## TOWN OF YORKTOWN PLANNING BOARD

### PUBLIC MEETING AGENDA YORKTOWN TOWN HALL BOARD ROOM 363 Underhill Avenue, Yorktown Heights, NY 10598

October 17, 2022  
7:00 PM

**To:** Planning Department  
**From:** ABACA  
**Date:** September 26, 2022  
**Subject:** Wendy's Restaurant at BJ's/Staples Plaza  
3399 Crompond Road; 27.14-1-45

### Architectural Rendering with Exterior Finish Schedule – Sheet A2.2

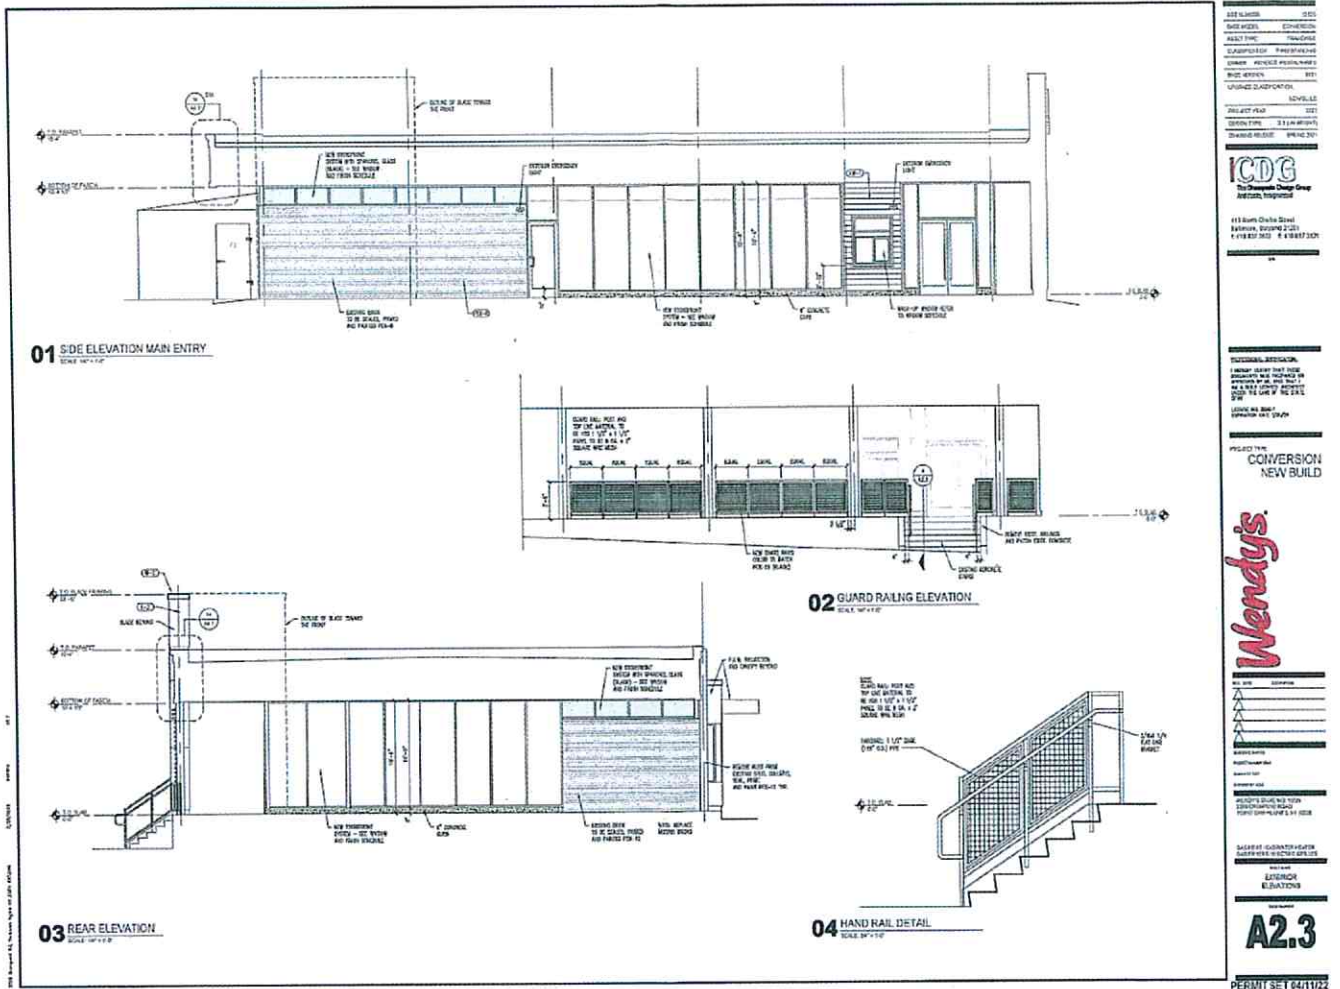
- The applicant addressed the Board's previous comments. The Board appreciates the integration of the cityscape screens to conceal the rooftop units; and the removal of the roof level flood lights.
- The material palette schedule proposed and presented is acceptable to the Board.
- As reflected in the submitted site plan, minor changes are proposed which are acceptable to the Board.

- Wall sconces are proposed at the drive-thru. All proposed new lighting on the site are to be LED.
- The Board requests for the applicant to submit a photovoltaic lighting plan to verify conformance of the proposed new lighting on the building and covered walkway.
- The Board requests for the applicant to submit cut sheets of all new proposed lighting fixtures.

**LANDSCAPE PLAN**

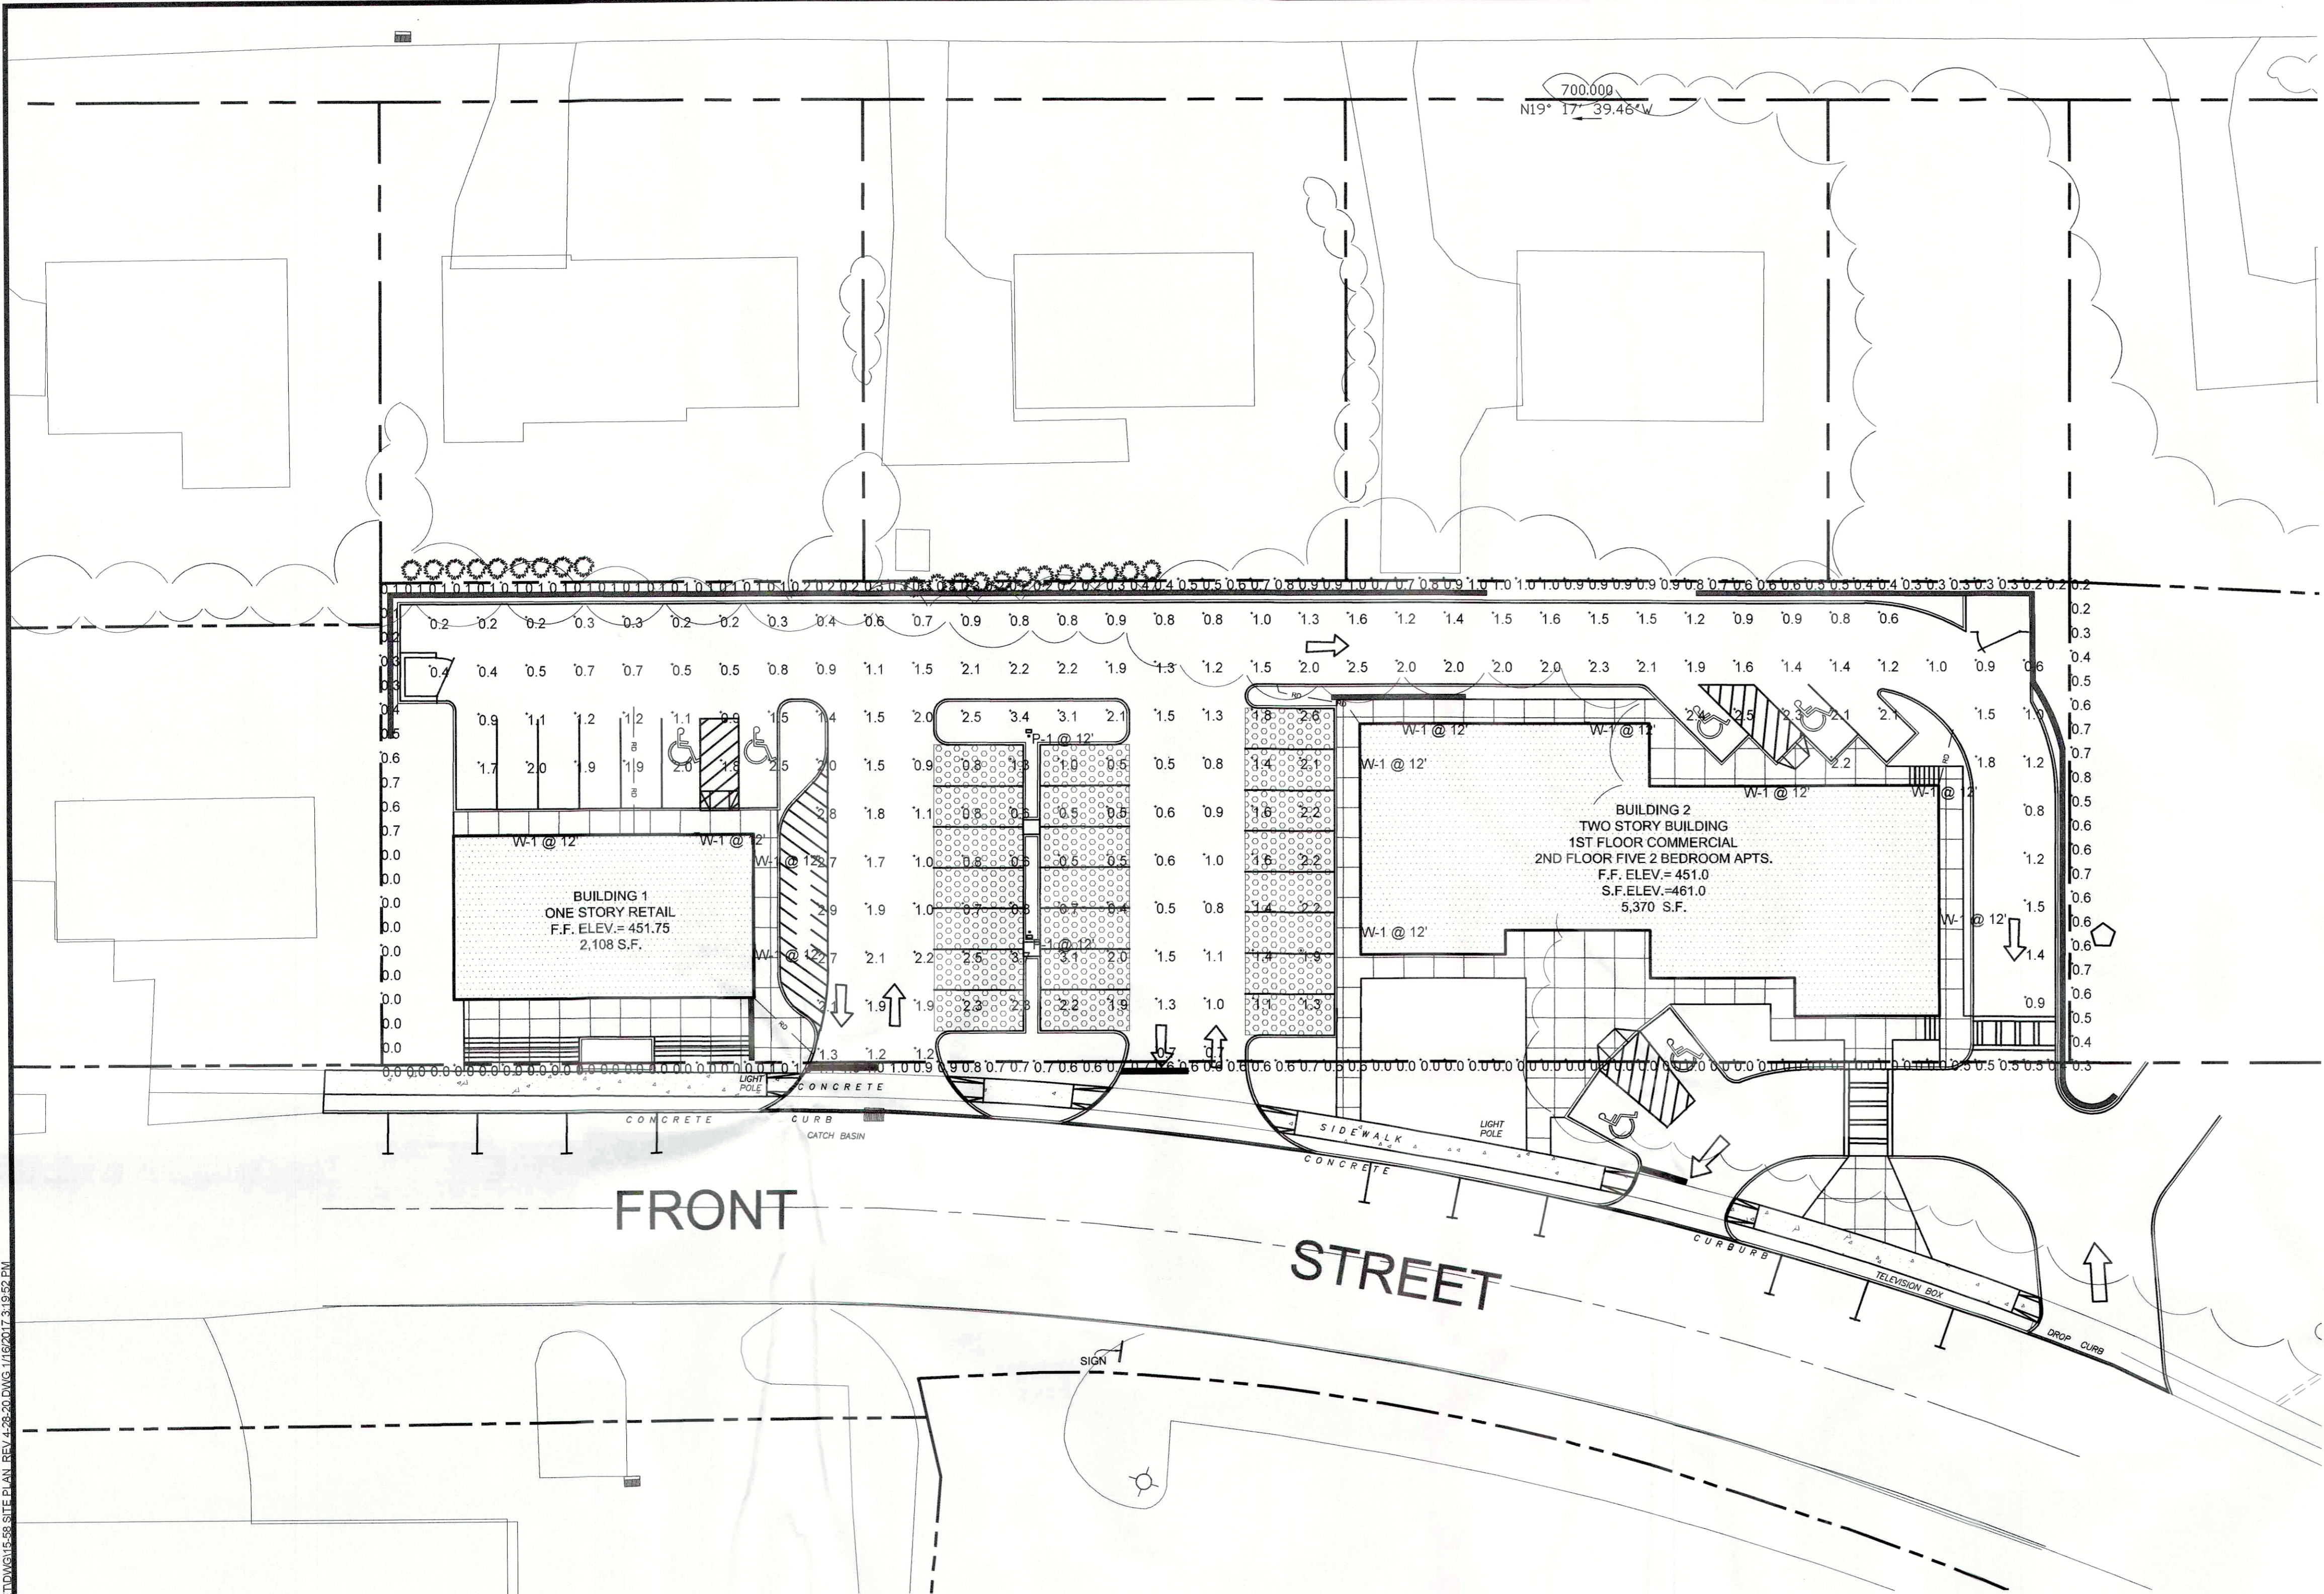
1. Revise Sheets 3 and 6 to reflect the revised site plan.
